**BOARD OF ZONING APPEALS
CITY OF PRAIRIE VILLAGE
TUESDAY, MARCH 5, 2024
7700 MISSION ROAD
COUNCIL CHAMBERS
6:30 P.M.**

STAFF REPORT

Application: BZA 2024-01

Application: BZA 2024-02

Mitch Dringman commented on Building Official Plan Review:

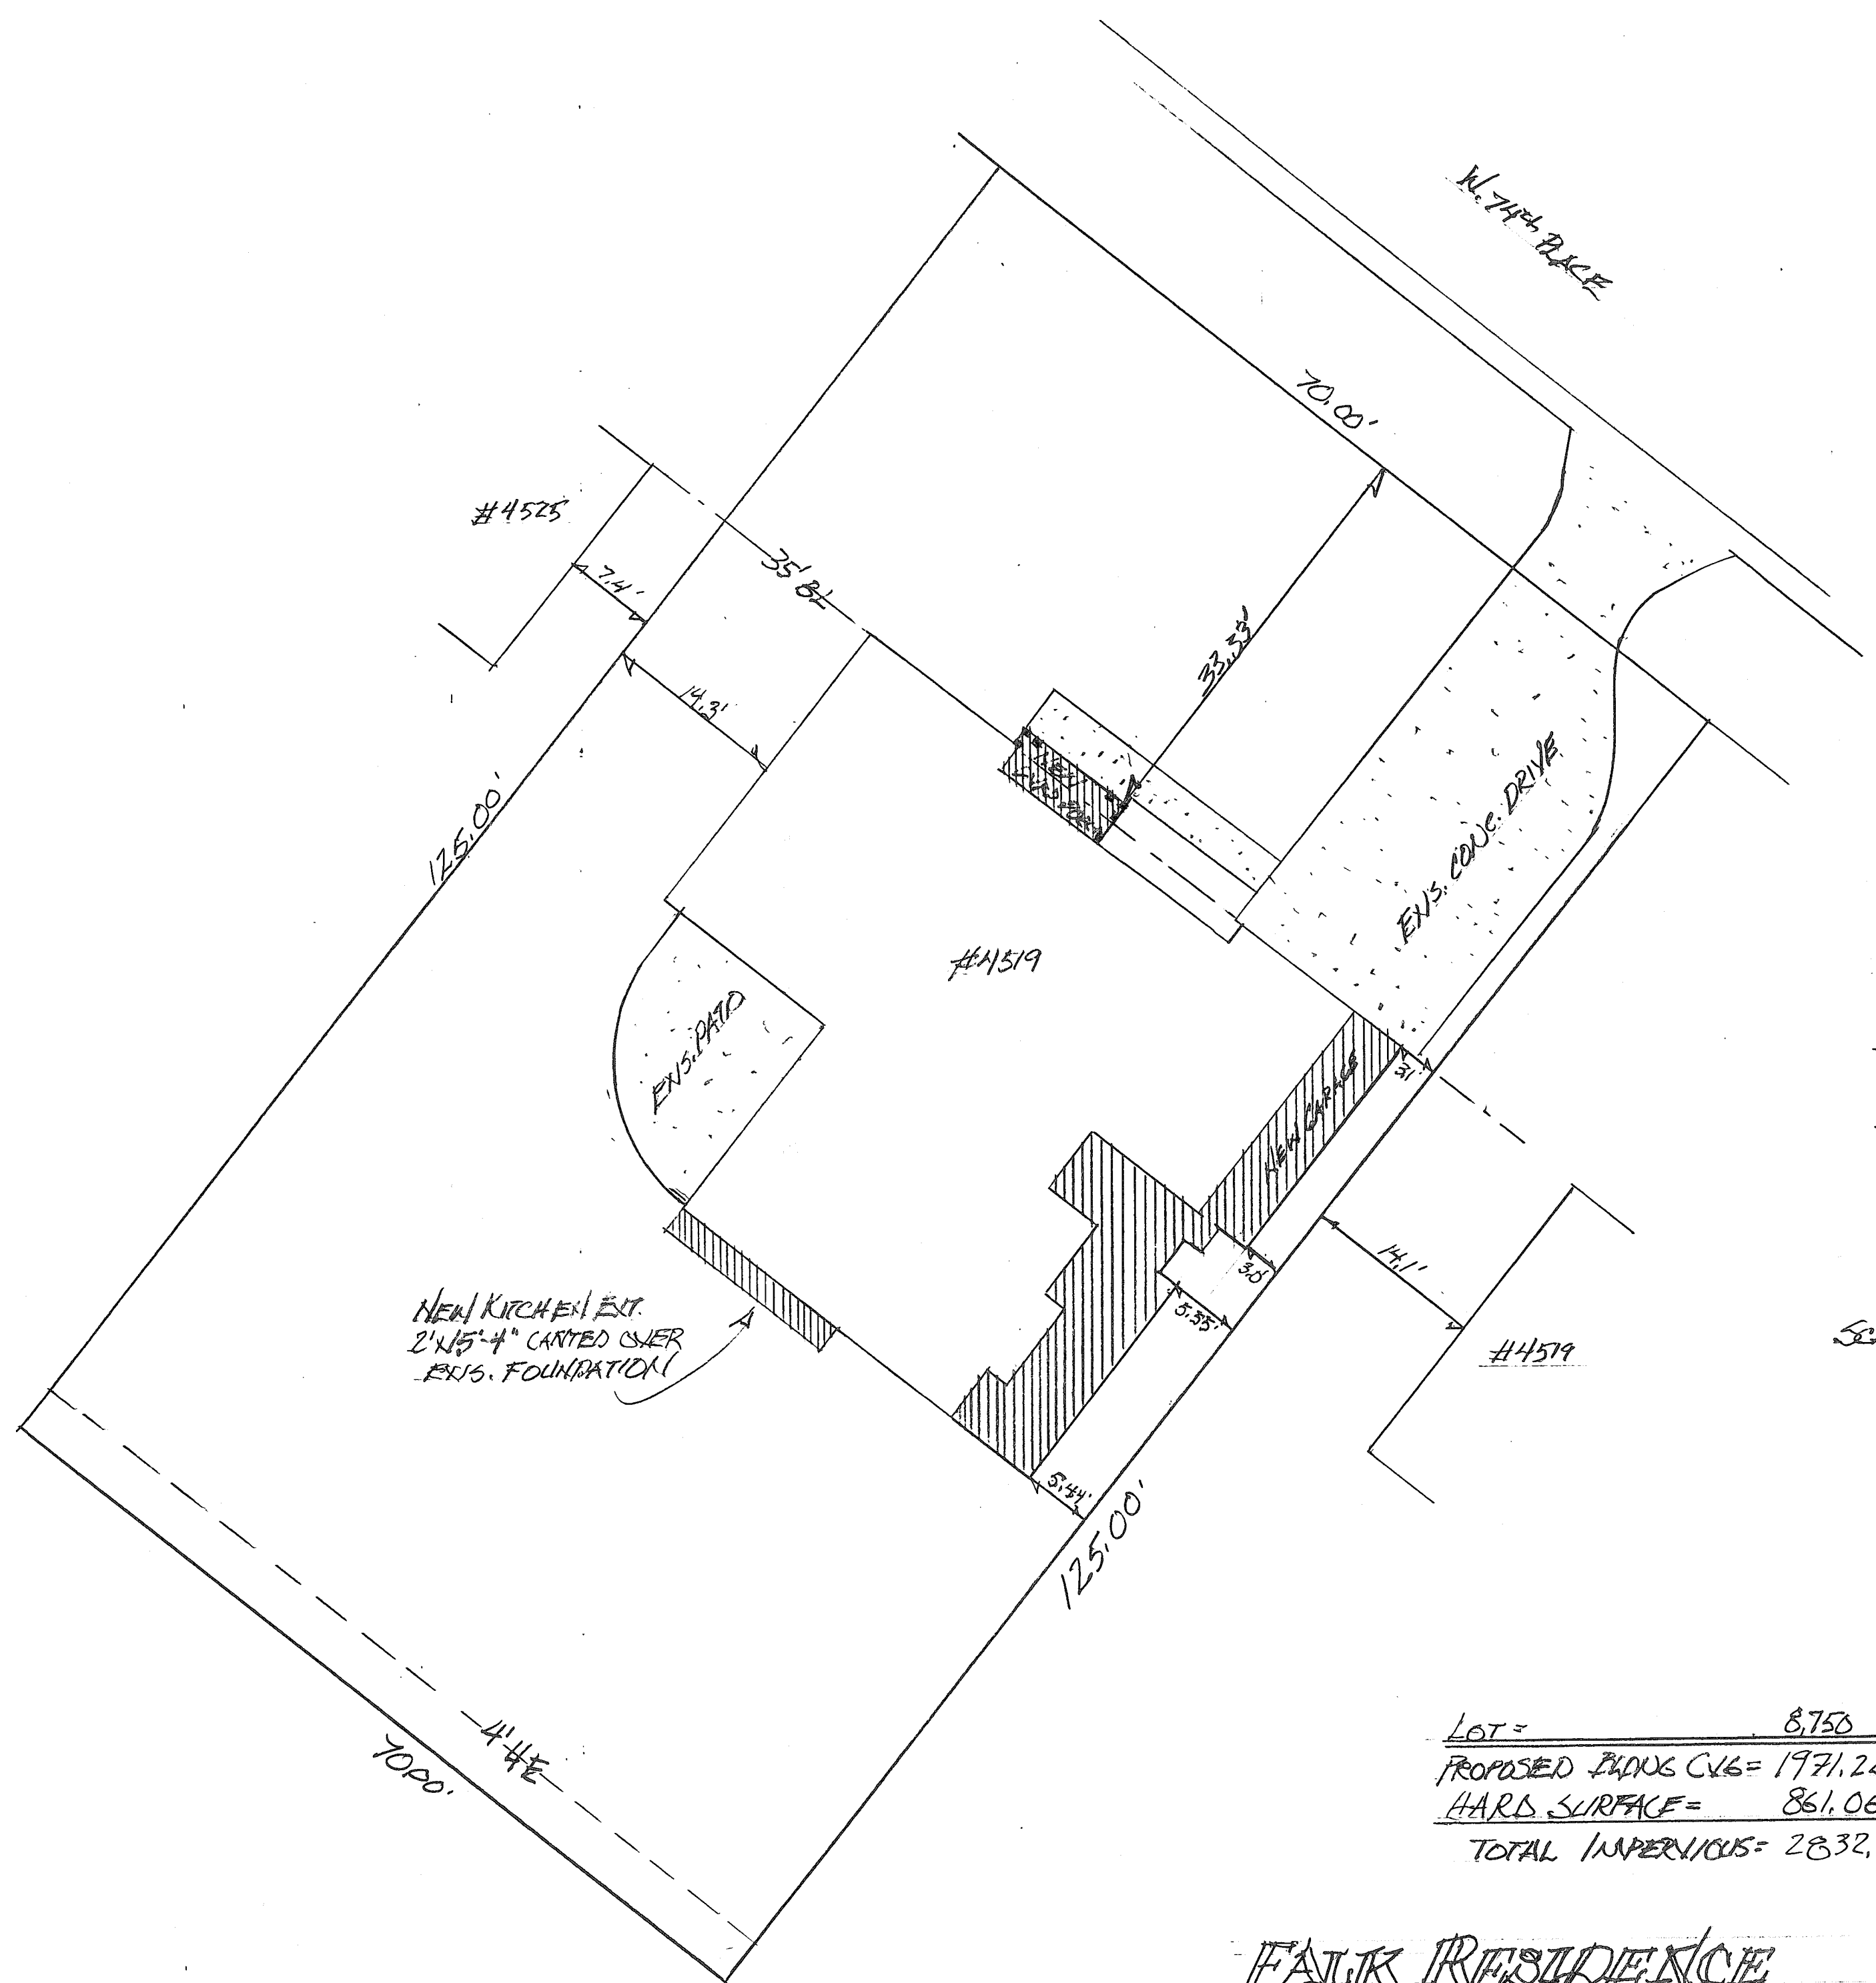
1. The proposed addition along the southeast side (left elevation) are too close to the side lot line new walls noted between 5.44' and 3' require a minimum of 6 feet side setback. This is a violation of PVZC Table 19.06 A Development standard. To build this configuration, it will require Board of Zoning Appeal review. (BZA)

2. The side wall of the newly proposed garage extension is within 5

feet to the side lot line, design requires 1 hour fire rating of the wall per IRC 2018 Table R302.1(1).

- General notation overall architectural design complies with Design guidelines per chapter 19.06 PVZC except distance to side lot line.
- No boundary survey information has been provided for this review, for the real plan submittal a topographical boundary survey is required.
- Applicants would also be required to submit a drainage permit application to the public works department.
- This review is limited to architectural review and is not a reflection of full building code review. Plans shall include energy compliance information.
